HISTORIC AND DESIGN REVIEW COMMISSION

HDRC CASE NO: 2023-475
ADDRESS: 222 S ALAMO ST
LEGAL DESCRIPTION: NCB 13814 (HEMISFAIR - NORTHWEST QUADRANT), BLOCK 3
LOT N IRR 218.54FT OF 18 *****LEASEHOLD ACCT*****
ZONING: D, H, RIO-3, Public Property
CITY COUNCIL DIST.: 1
DISTRICT: Hemisfair Historic District
APPLICANT: Michael Monceaux/Overland Partners
OWNER: Greg Hale/ZACHRY PARK HOTEL QOZB LLC
TYPE OF WORK: Amendment to the previously approved design and stipulation of approval
regarding the screening of rooftop mechanical equipment
APPLICATION RECEIVED: October 02, 2024
60-DAY REVIEW: December 01, 2024 (Postponed to January 15)
CASE MANAGER: Edward Hall
REQUEST:

The applicant is requesting a Certificate of Appropriateness to amend the previously approved design and stipulation of approval regarding the screening of rooftop mechanical equipment.

HEMISFAIR HOTEL

VIEW SHED 1 - SOUTH

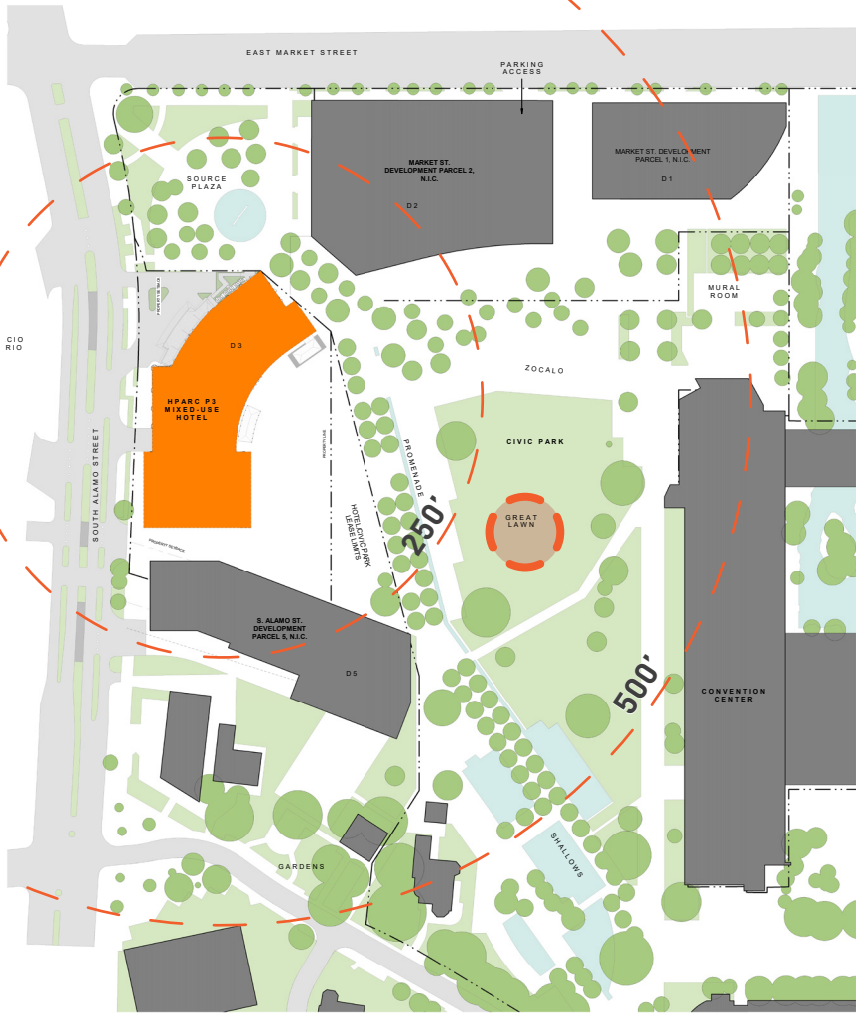
That all mechanical equipment be screened from view with architectural building elements, as noted in finding j. This is to include roof level mechanical equipment. The roof level screening element should feature compatible materials and be submitted to for review and approval.

RECOMMENDATION v | HOTEL DESIGN | DESIGN SCREENS EQUIPMENT THROUGH GEOMETRY, CREATING A WELL FOR EQUIPMENT, AND SIGHT LINES

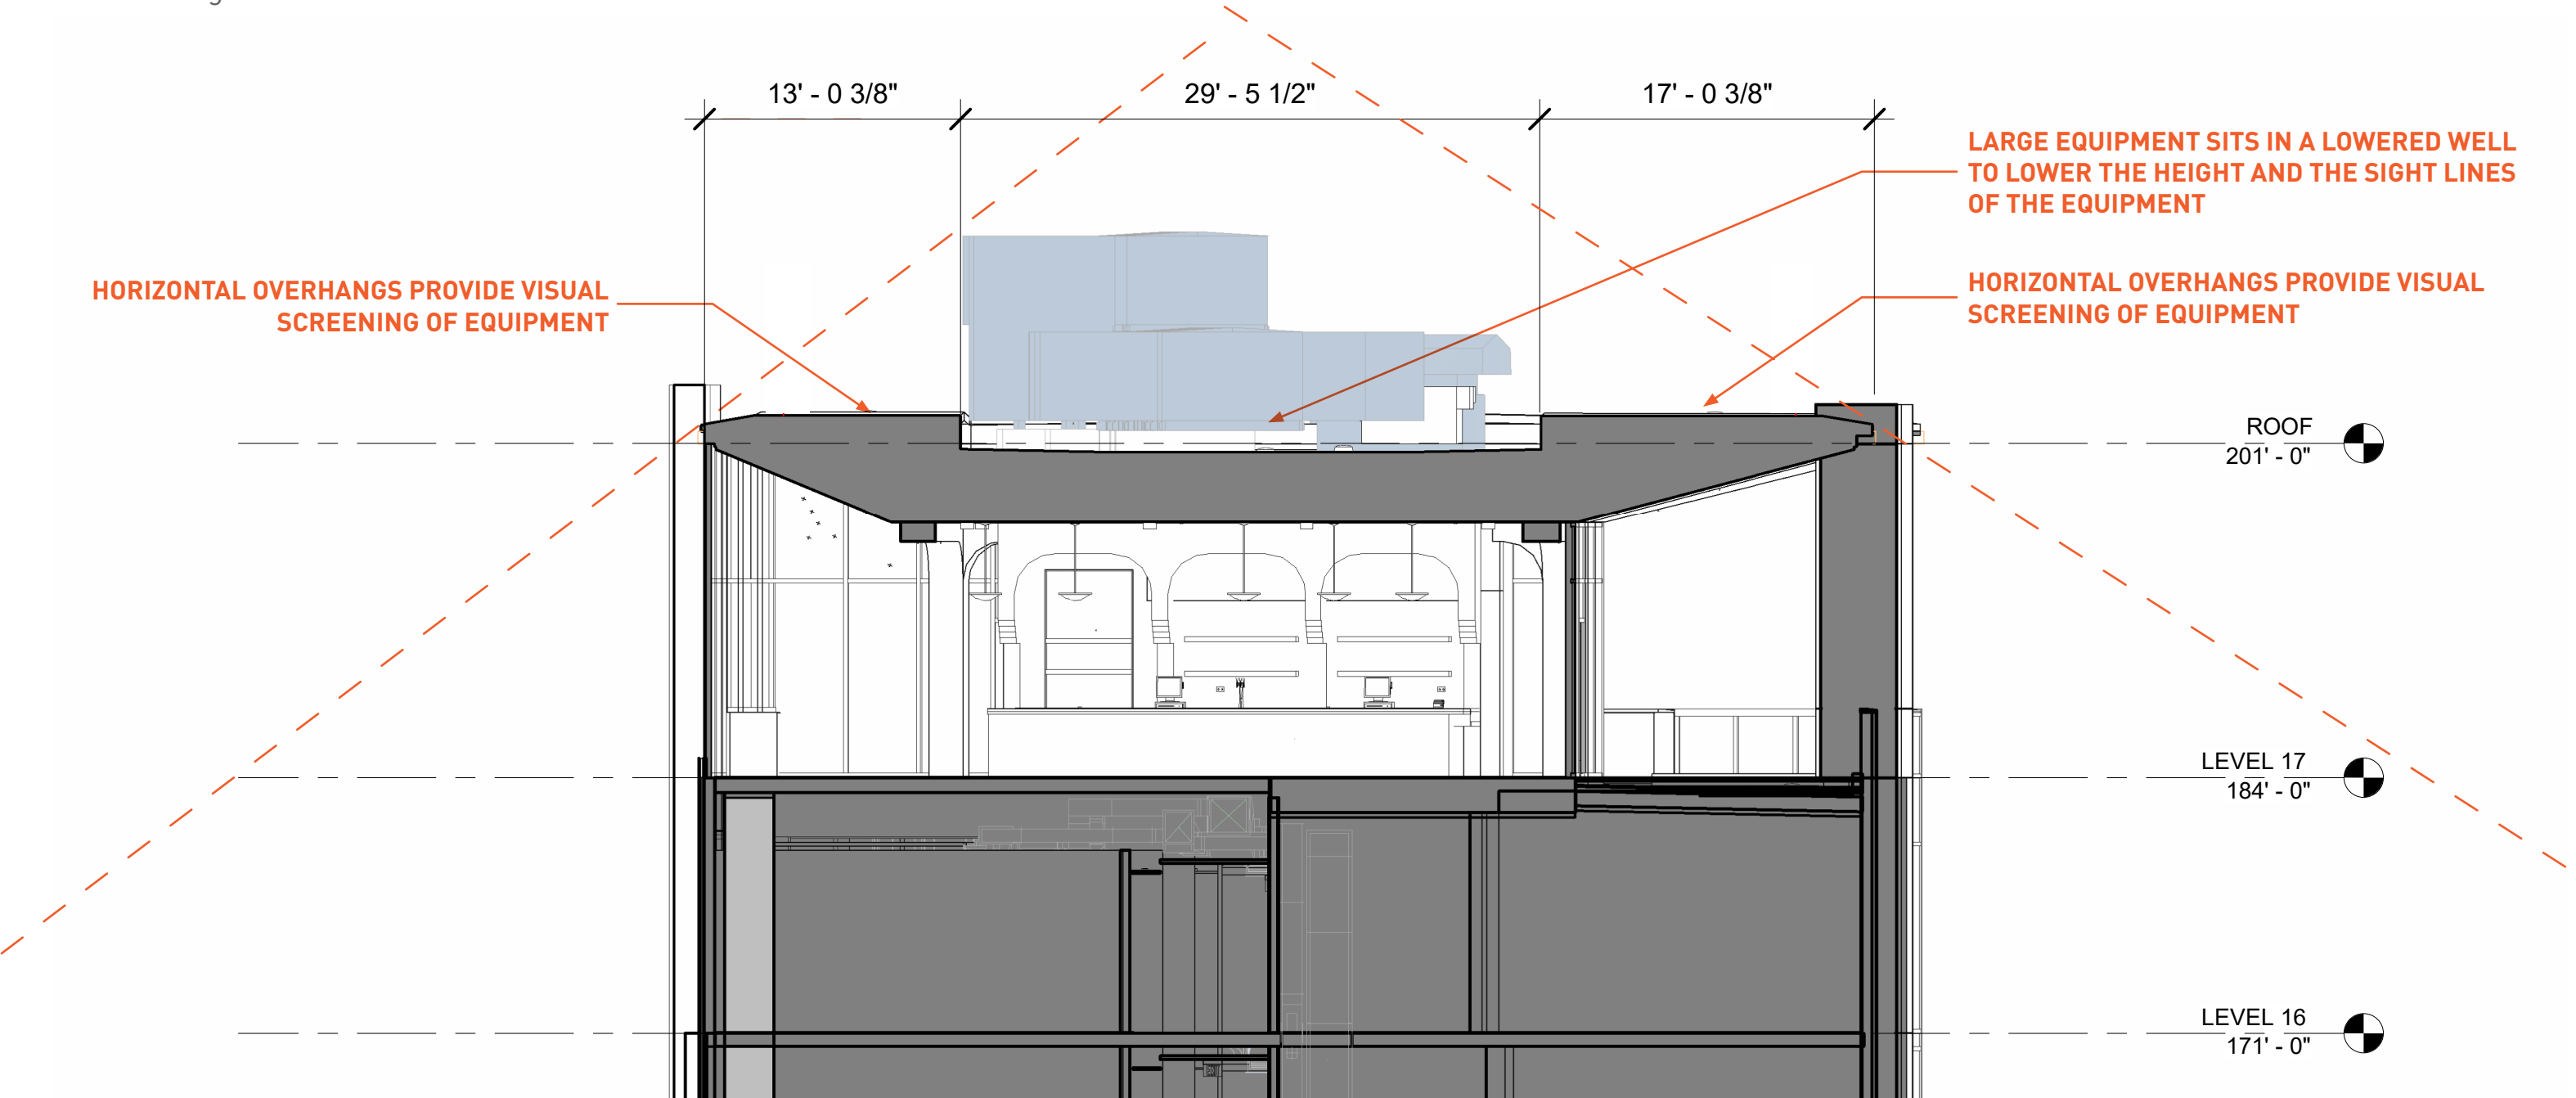
That all mechanical equipment be screened from view with architectural building elements, as noted in finding j. This is to include roof level mechanical equipment. The roof level screening element should feature compatible materials and be submitted to OHP for review and approval. Equipment to be visually unobtrusive and should be integrated into the design.

j. MECHANICAL EQUIPMENT – The UDC Section 35-673(n) addresses service areas and mechanical equipment and their impact in the public. Service areas and mechanical equipment should be visually unobtrusive and should be integrated with the design of the site and building. Noise generated from mechanical equipment shall not exceed city noise regulations. Staff finds that all mechanical and service equipment should be screened and integrated into the design of the site and building, as required by the UDC. This includes all roof level equipment. A roof level screening element should be designed and submitted to for review and approval.

RECOMMENDATION v | HPARC CONCERN WITH THE VIEW FROM PALACIO BALLROOM | STUDY ADDING A PHYSICAL SCREEN ELEMENT

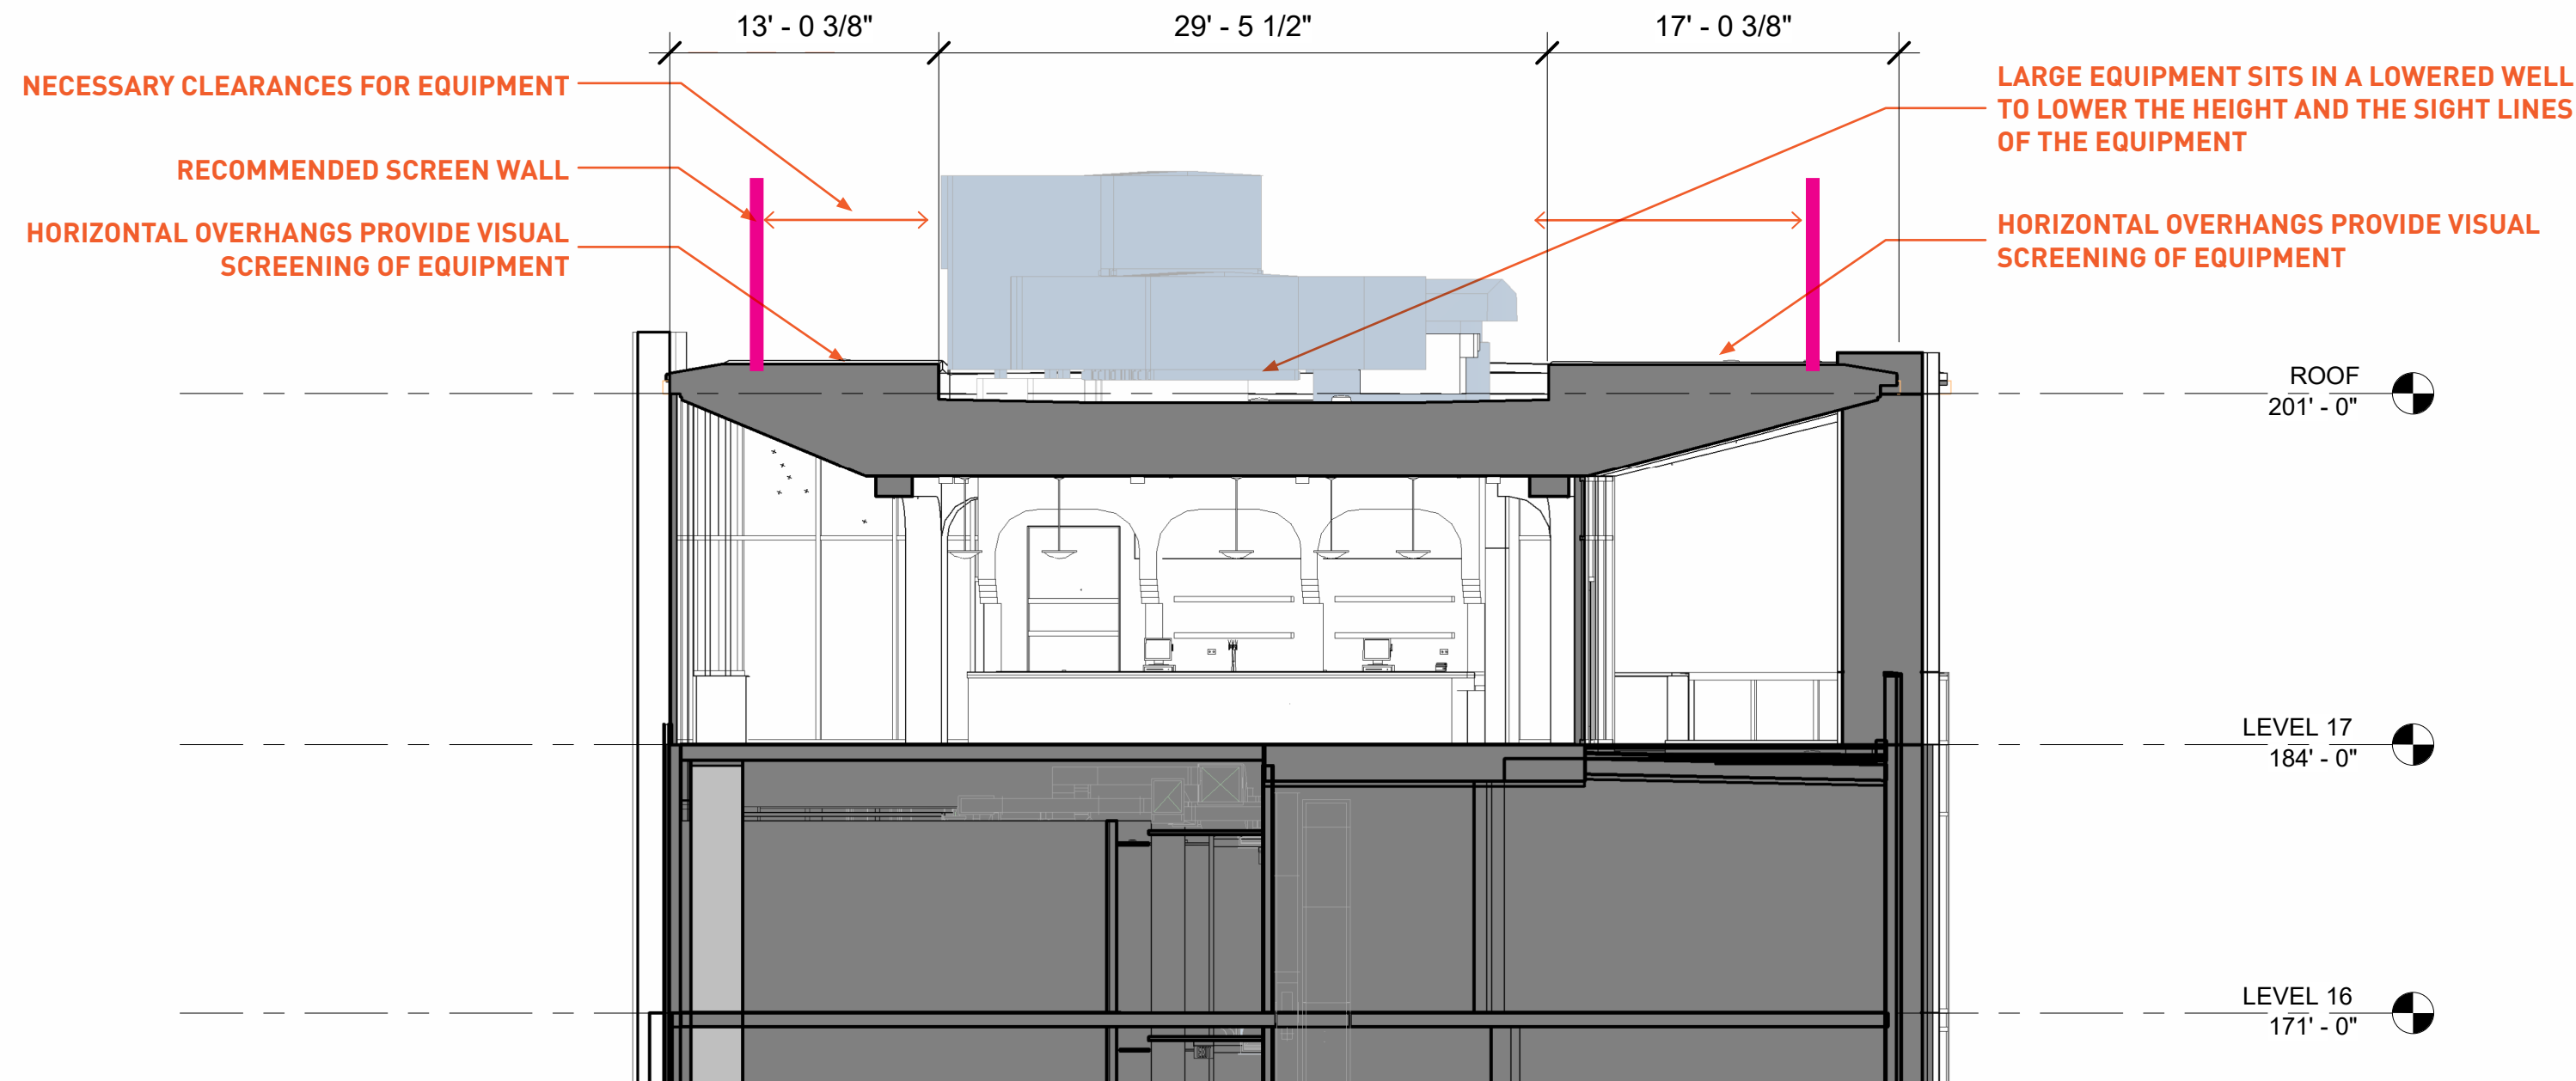
JF: Could views from the Palacio's ballroom be provided to determine what will be seen? Is there a way to screen some or all of the equipment from the ballroom's view?

That all mechanical equipment be screened from view with architectural building elements, as noted in finding j. This is to include roof level mechanical equipment. The roof level screening element should feature compatible materials and be submitted to OHP for review and approval. Equipment to be visually unobtrusive and should be integrated into the design.

j. MECHANICAL EQUIPMENT – The UDC Section 35-673(n) addresses service areas and mechanical equipment and their impact in the public. Service areas and mechanical equipment should be visually unobtrusive and should be integrated with the design of the site and building. Noise generated from mechanical equipment shall not exceed city noise regulations. Staff finds that all mechanical and service equipment should be screened and integrated into the design of the site and building, as required by the UDC. This includes all roof level equipment. A roof level screening element should be designed and submitted to for review and approval.

VIEW SHED 2 - EAST WITH SCREEN

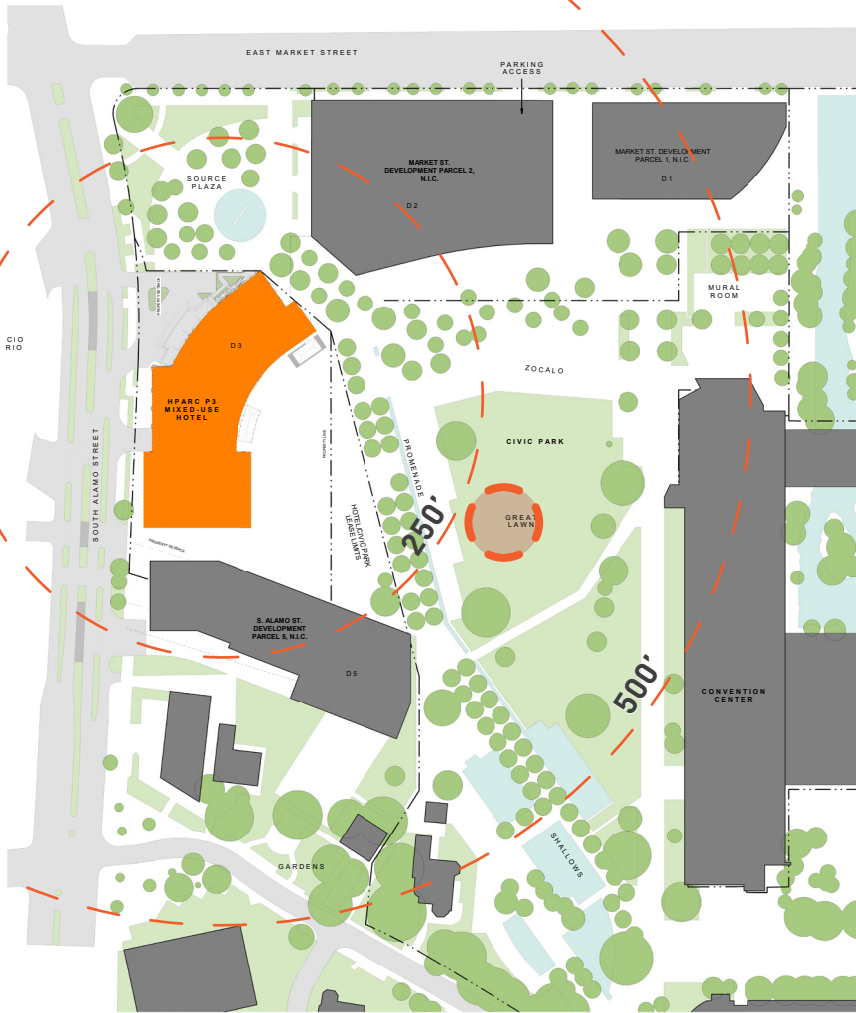
That all mechanical equipment be screened from view with architectural building elements, as noted in finding j. This is to include roof level mechanical equipment. The roof level screening element should feature compatible materials and be submitted to for review and approval.

VIEW FROM PALACIO BALLROOM

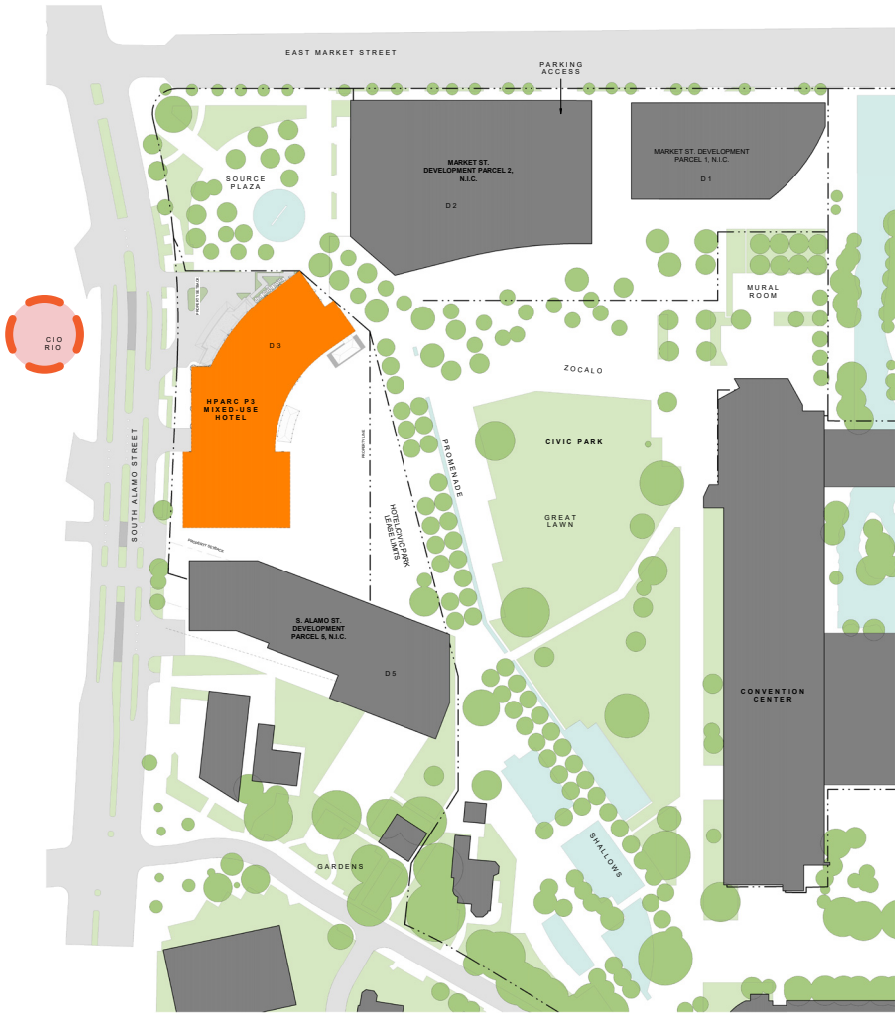
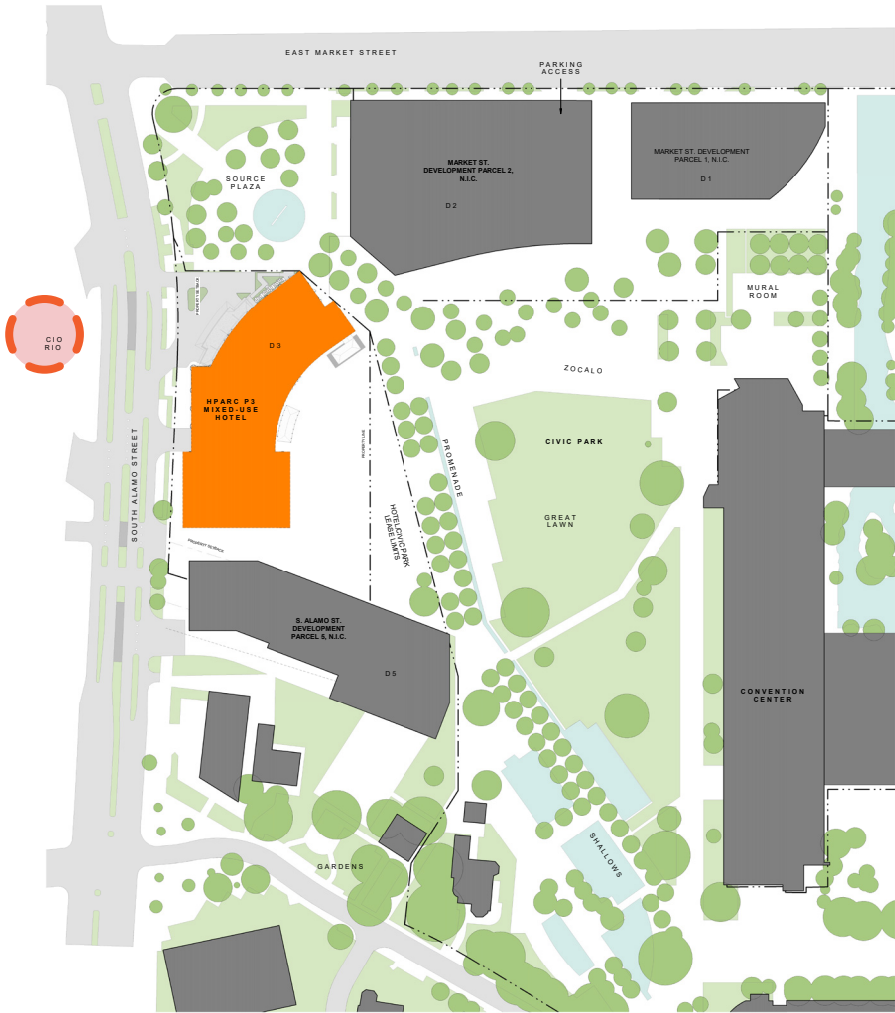
That all mechanical equipment be screened from view with architectural building elements, as noted in finding j. This is to include roof level mechanical equipment. The roof level screening element should feature compatible materials and be submitted to for review and approval.

That all mechanical equipment be screened from view with architectural building elements, as noted in finding j. This is to include roof level mechanical equipment. The roof level screening element should feature compatible materials and be submitted to for review and approval.

6' SCREENING ELEMENT
